UNITED STATES PATENT AND TRADEMARK OFFICE

APPLICATION NO.	FILING DATE	FIRST NAMED INVENTOR	ATTORNEY DOCKET NO.	CONFIRMATION NO.
10/527,464	03/11/2005	Masashi Iwata	Q86804	3586
23373	7590	11/29/2005	EXAMINER	
SUGHRUE MION, PLLC 2100 PENNSYLVANIA AVENUE, N.W. SUITE 800 WASHINGTON, DC 20037			NGUYEN, PHUONGCHI T	
			ART UNIT	PAPER NUMBER
			2833

Office Action Summary

DETAILED ACTION

Attachment 1

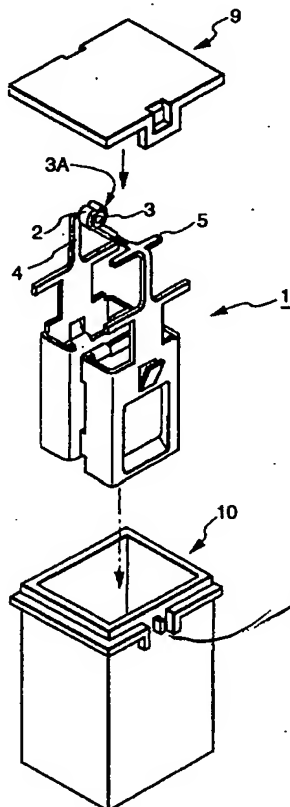
In regards to claim 1, Hanazaki et al discloses a fuse (1) comprising a fuse body (of 1); a housing (10) which is made of an insulative resin, and receives and holds the fuse body (of 1) therein, and into which the fuse body (of 1) is inserted through an upper opening (at one end of 10) in the housing (10); and a cover (9) which is made of an insulative resin, and covers the upper opening (at one end of 10) in the housing (10), wherein a retaining portion (R) is formed on a side surface of the housing (attachment 1). "Corresponding to a retaining claw of a

In regards to claims 3 and 4, Hanazaki et al discloses the fuse wherein a pair of the retaining portions (R, R) (on both sides of 10) are provided on opposite side faces of the housing (10) so that the retaining portions (R, R) are aligned in an extending direction of a fusible portion (body of 1)/terminal portions (body of 1) of the fuse body (of 1).

Attachment 2
1st ridge portion
2nd ridge portion

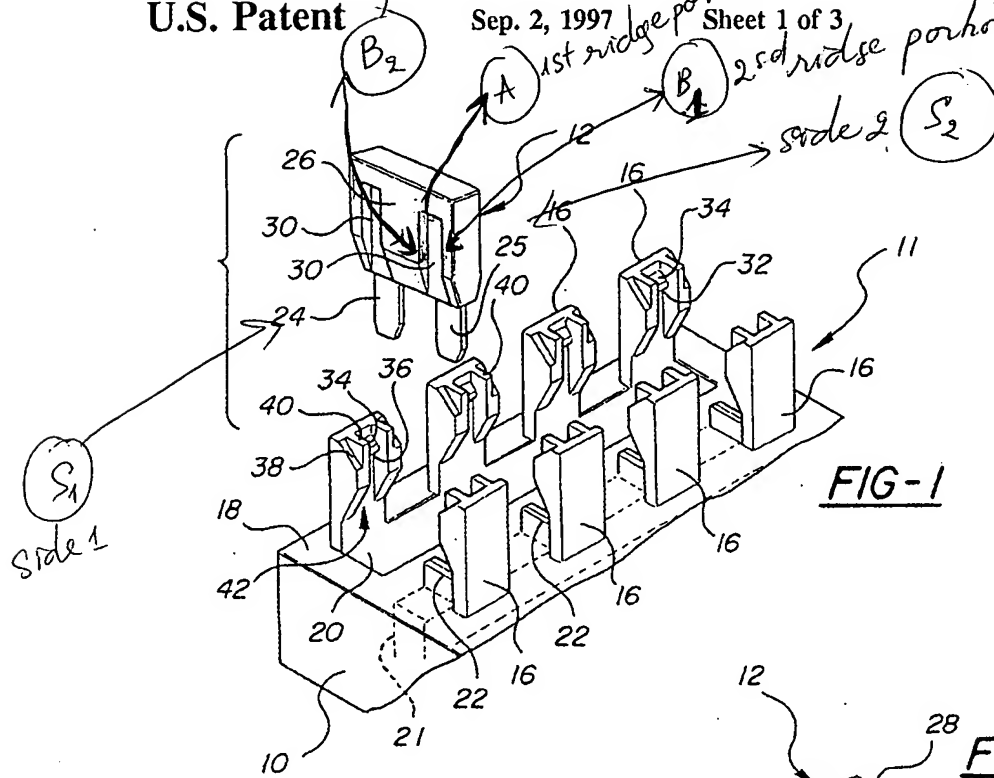
In regards to claim 2, Hanazaki et al discloses the invention general substantially as claimed, but lacks the first and second ridges of the retaining portion. Kanamori discloses the fuse wherein the retaining portion (30) includes a first ridge portion (A) which is formed at an upper portion of the side surface of the housing (10), and is disposed perpendicularly to a longitudinal axis of the housing (10), and two second ridge portions (B1, B2) which extend perpendicularly from opposite ends of the first ridge portion (A), respectively, and are disposed parallel to the longitudinal axis of the housing (10) (attachment 2). It would have been obvious to one having ordinary skill at the time the invention was made to modify the fuse of Hanazaki et al

by having the ridges as taught by Kanamori on the retaining portion of the fuse for ease pulling the fuse out of the system housing.
